# Service Bulletin SB-0018

**Subject:** Left Circuit Breaker Panel Bus Bar Interference

**Affected Model(s):** E1000

**Figure 1:** Left Circuit Breaker Panel Bus Bar Interference

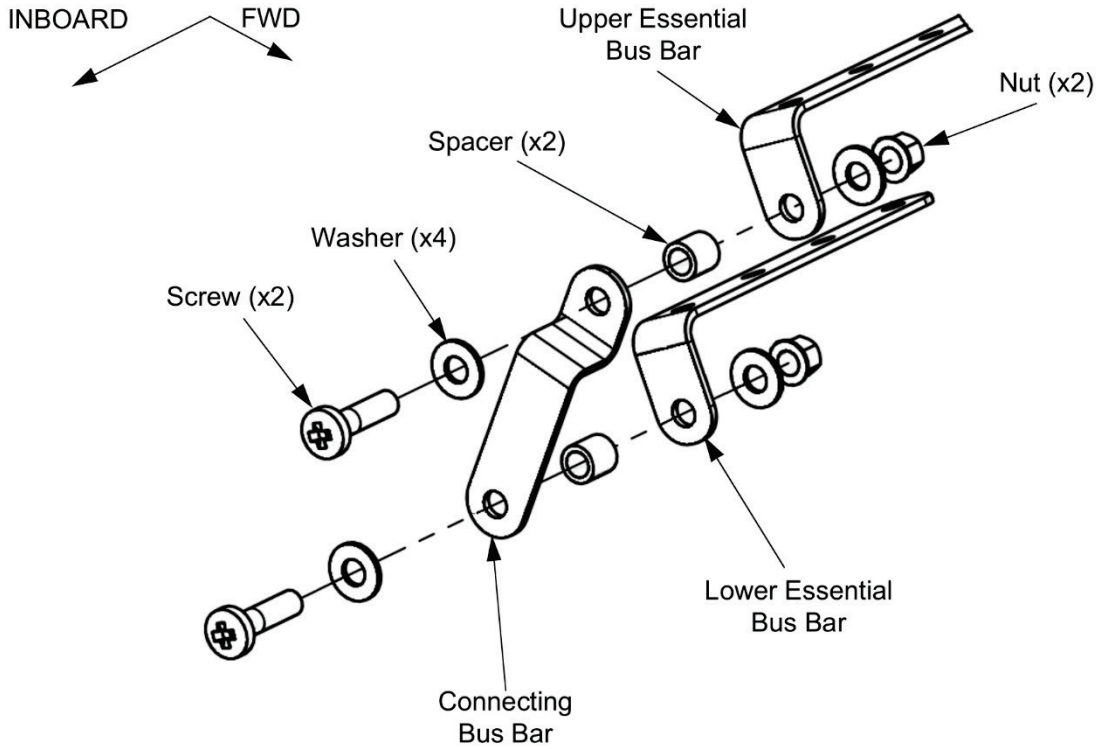
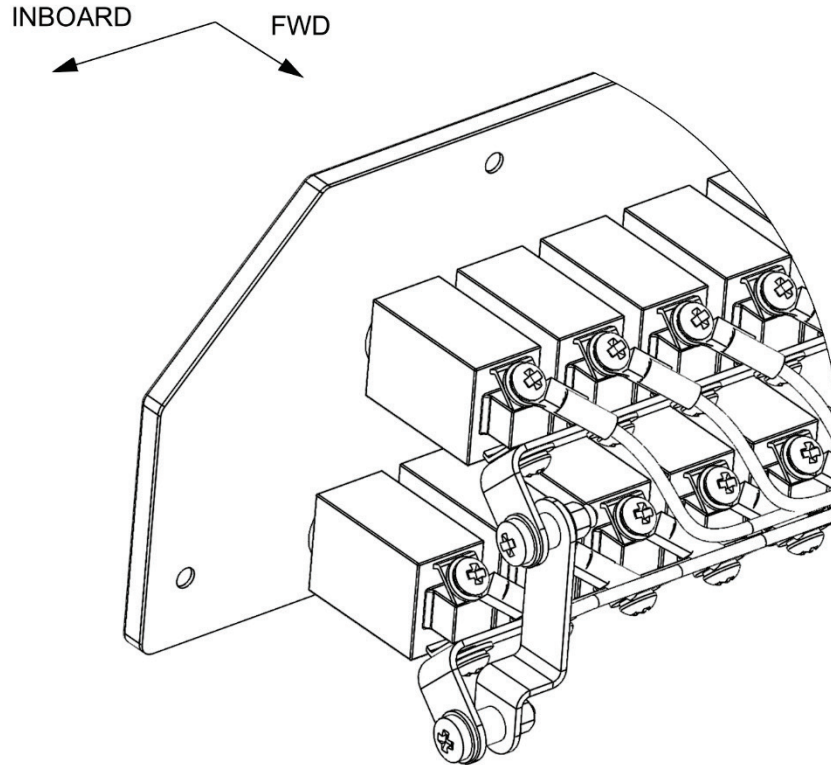
On affected aircraft, it has been found that the connecting bus bar between the long (upper) and short (lower) essential bus bars on the left circuit breaker panel may be close to contacting structure, causing the potential of an electrical short.

This Service Bulletin contains instructions to install the connecting bus bar in a different orientation to prevent the possibility of an electrical short.

**D)** Remove the nuts, washers spacers and screws that attach the connecting bus bar to the upper and lower essential bus bars (refer to Figure 2). Retain all hardware.

Before modification, shown exploded for clarity. Reinstall as shown in Figure 2.

**F)** Install the connecting bus bar to the upper and lower essential bus bars with the retained hardware (refer to Figure 3).

Shown after modification.
